Palladium at Aero Drive

Kearny Mesa Community Plan – Draft Amendment

In response to comments received at the Planning Commission hearing on October 16, 2008, I am writing to share changes made to the Palladium at Aero project. We appreciate the candor of the Planning Commissioners and feel that the changes made respond directly to the issues you raised.

Palladium at Aero has been substantially redesigned in response to the comments that we heard from the Planning Commission and representatives of the adjacent Serra Mesa community at the hearing on October 16. Changes have been made to the project height, site plan and architectural treatments on the east, west and north sides.

ORIGINAL RENDERING
CORNER OF AERO DRIVE AND SANDROCK ROAD

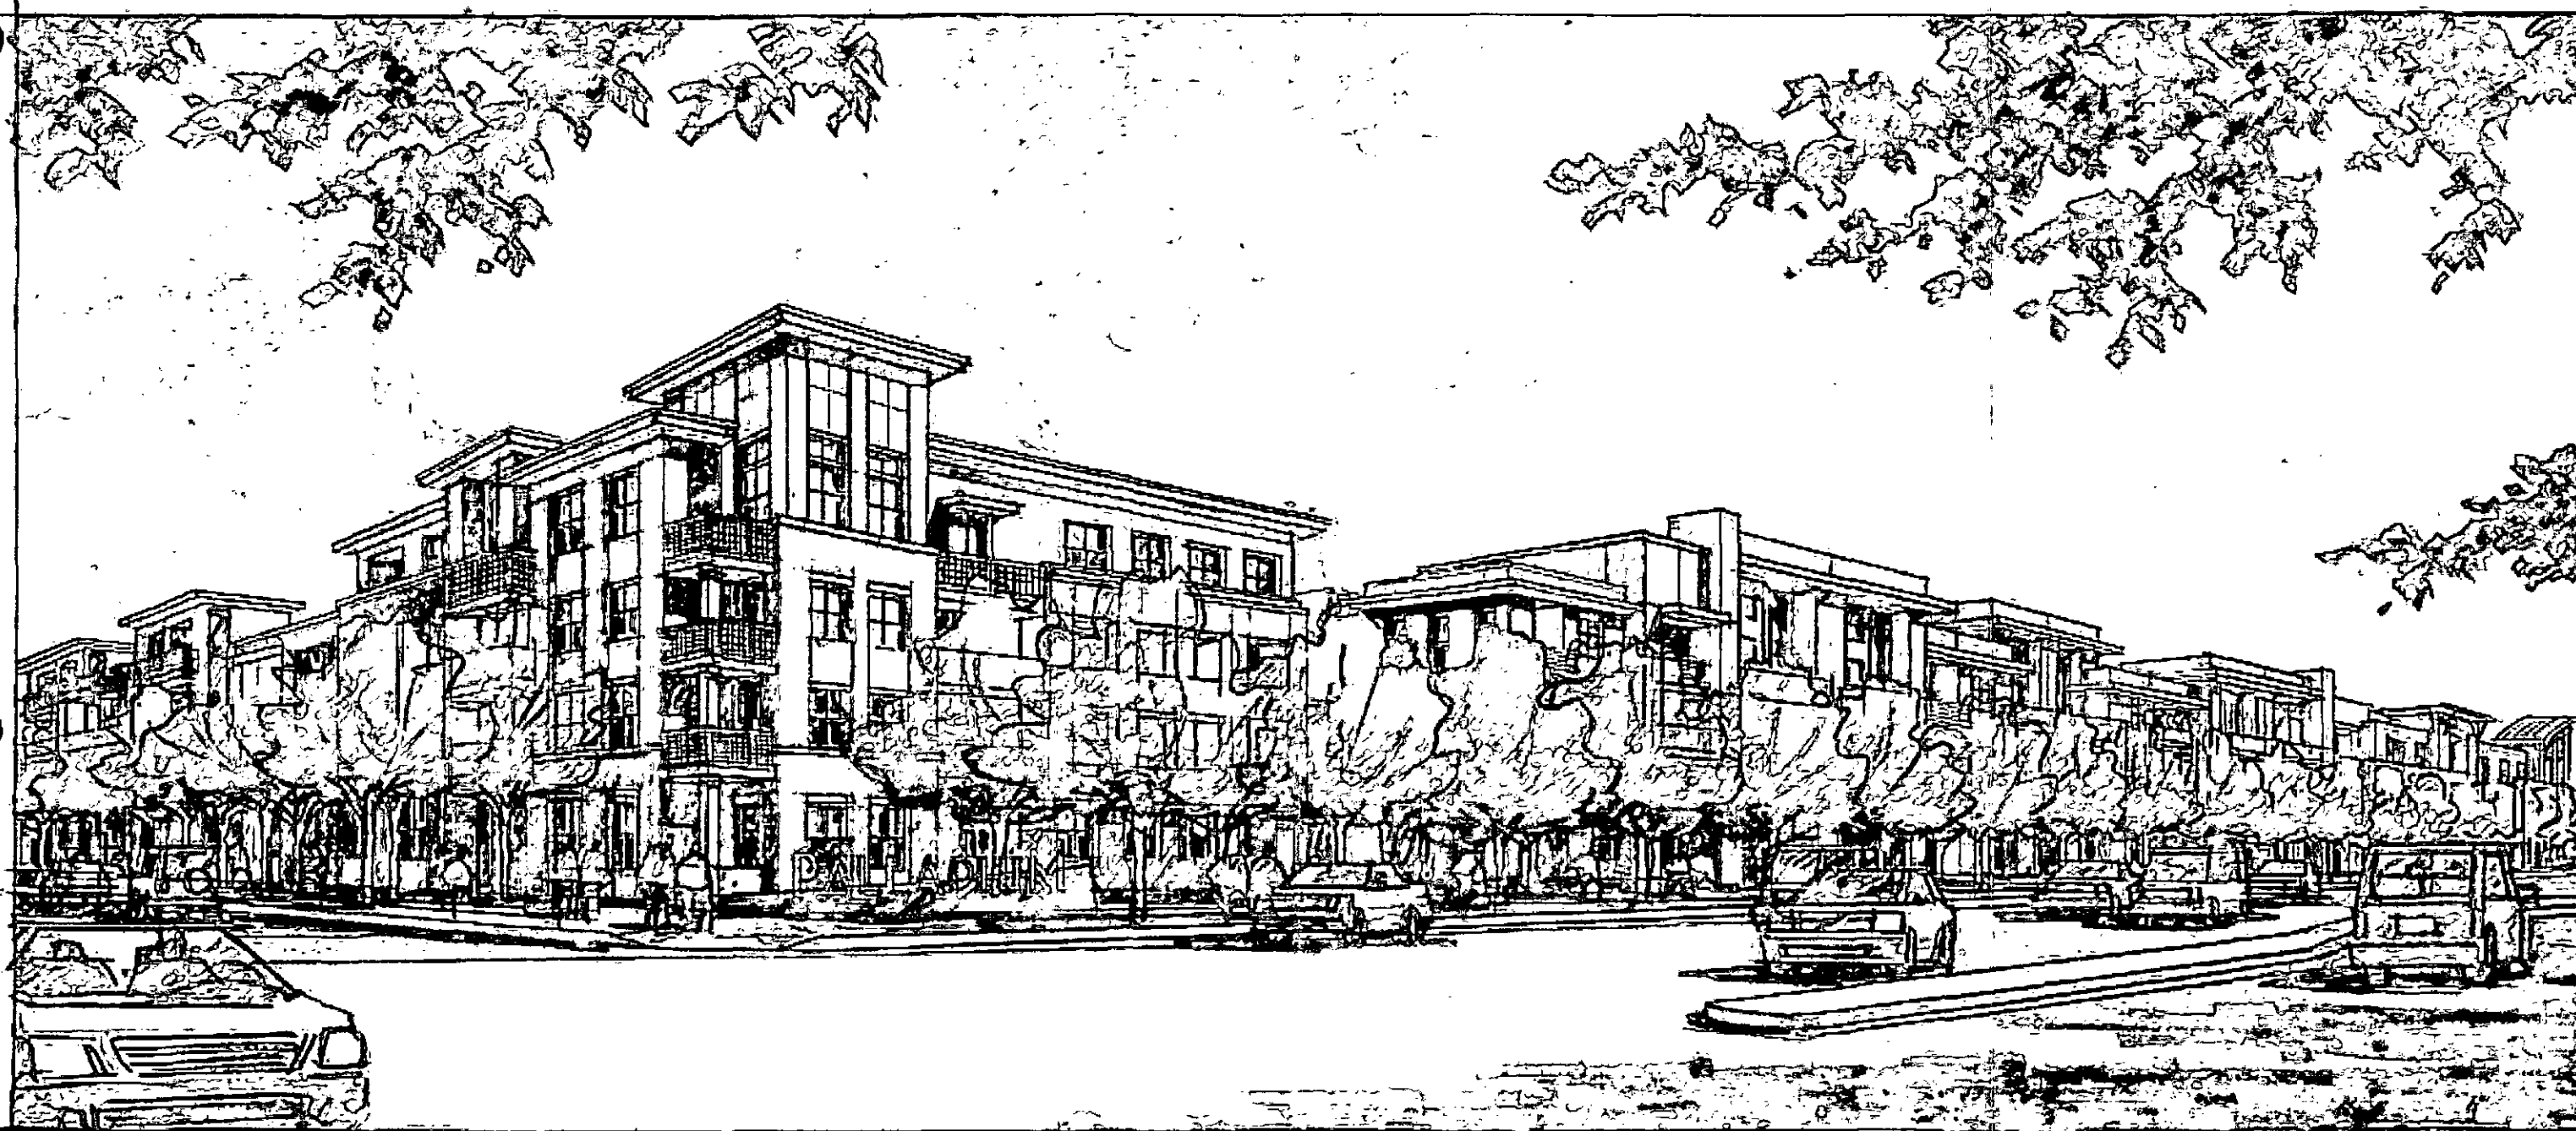
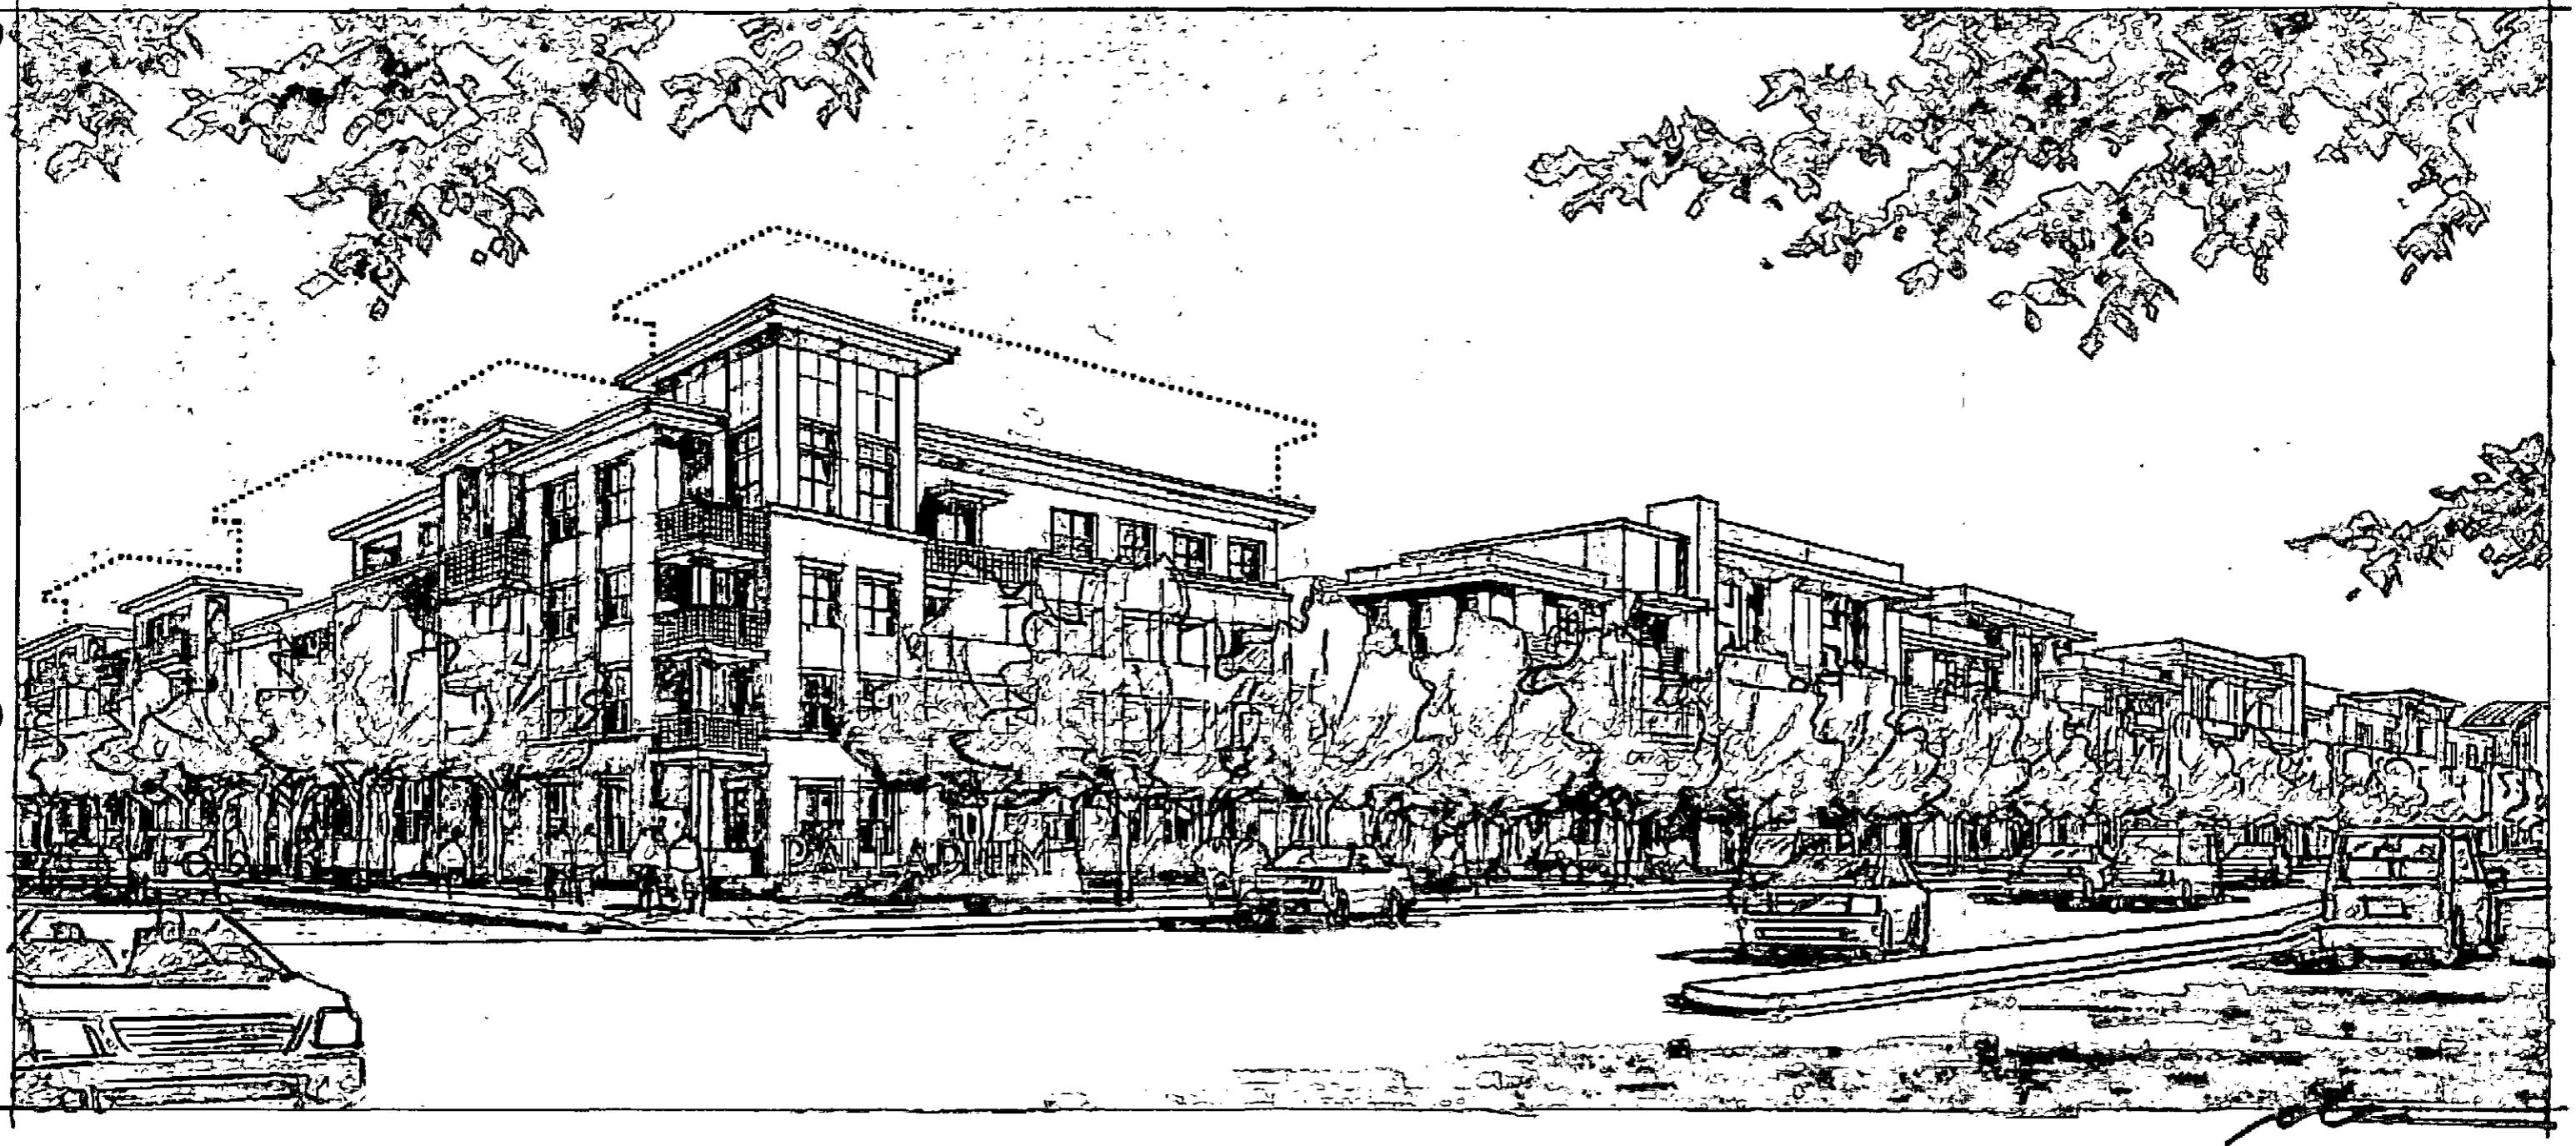
The project's eastern frontage (Sandrock Road) has been revised to acknowledge the transition from urban development to the single family neighborhood to the south.

NEW PROPOSED PERSPECTIVE RENDERING
CORNER OF AERO DRIVE AND SANDROCK ROAD

ORIGINAL WEST ELEVATION

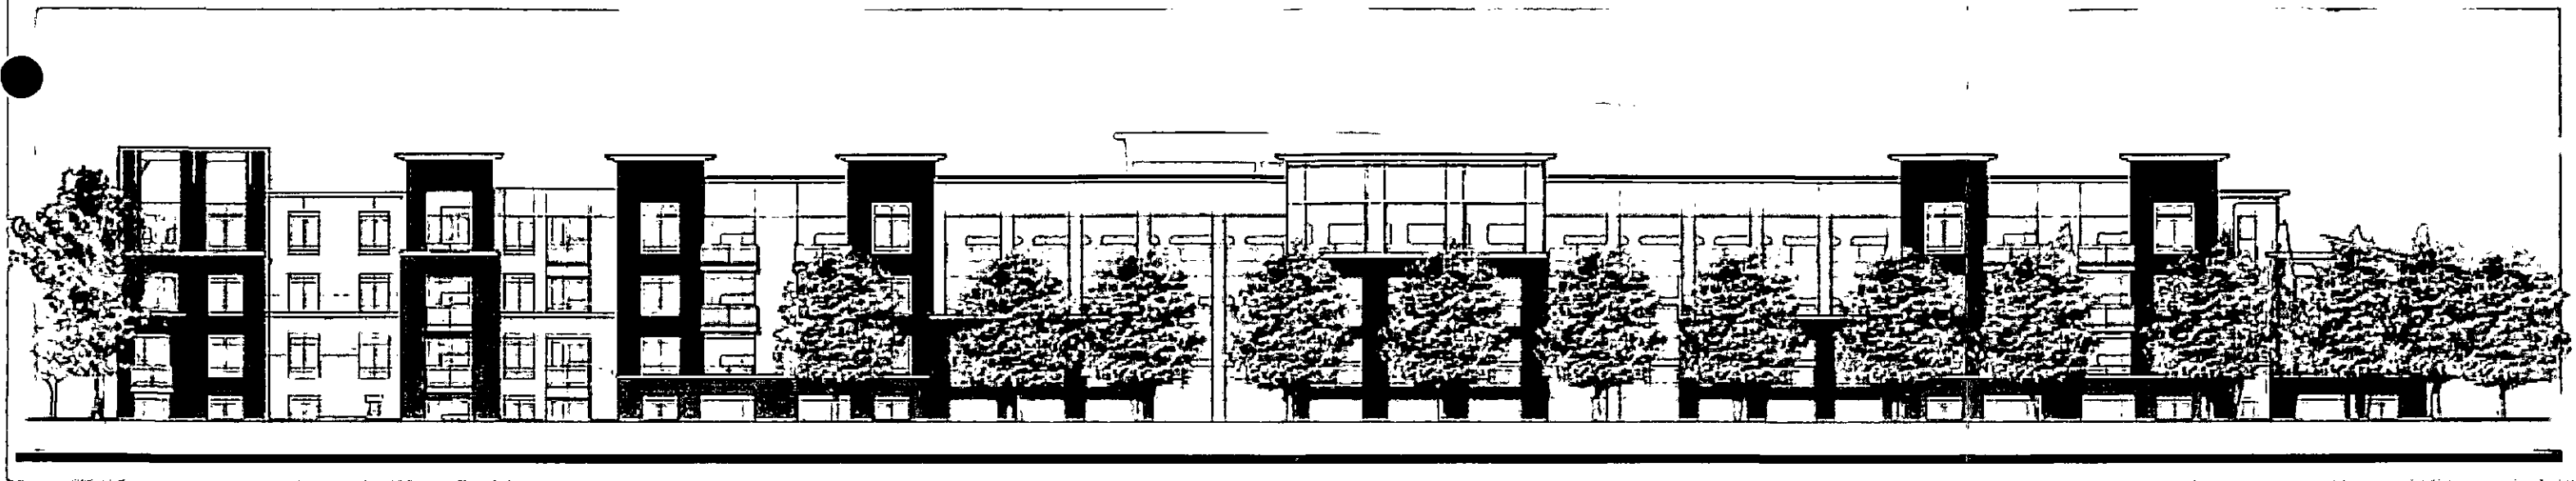
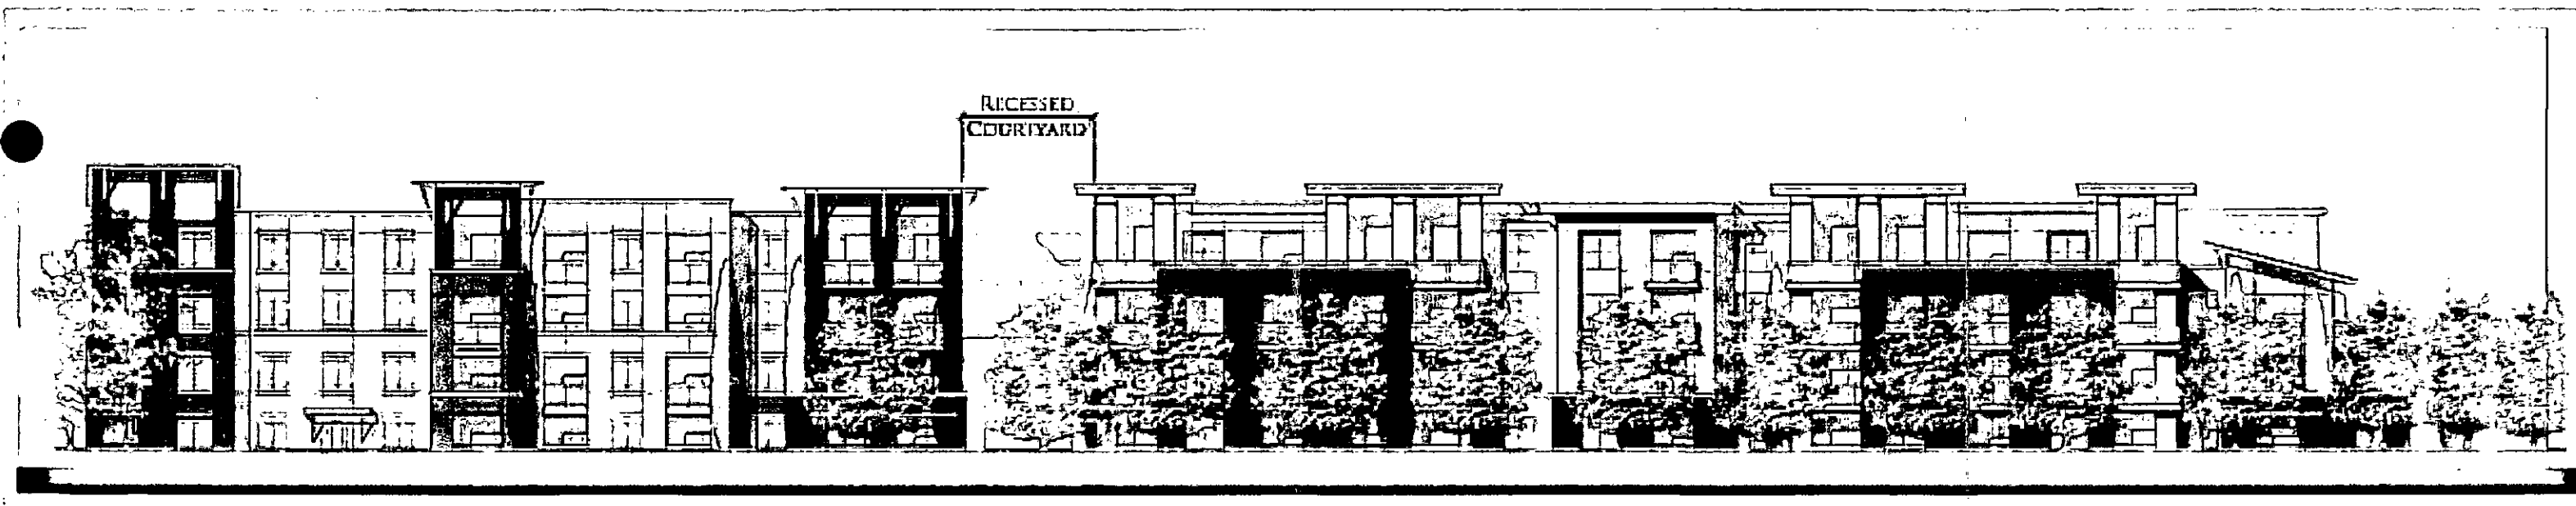
Plans for the west elevation of the project have also been redesigned. An exterior corridor was relocated to the interior of the project to allow for dwelling units to face outward, creating more articulation and architectural interest on this side of the project. A courtyard has also been

PROPOSED NEW WEST ELEVATION
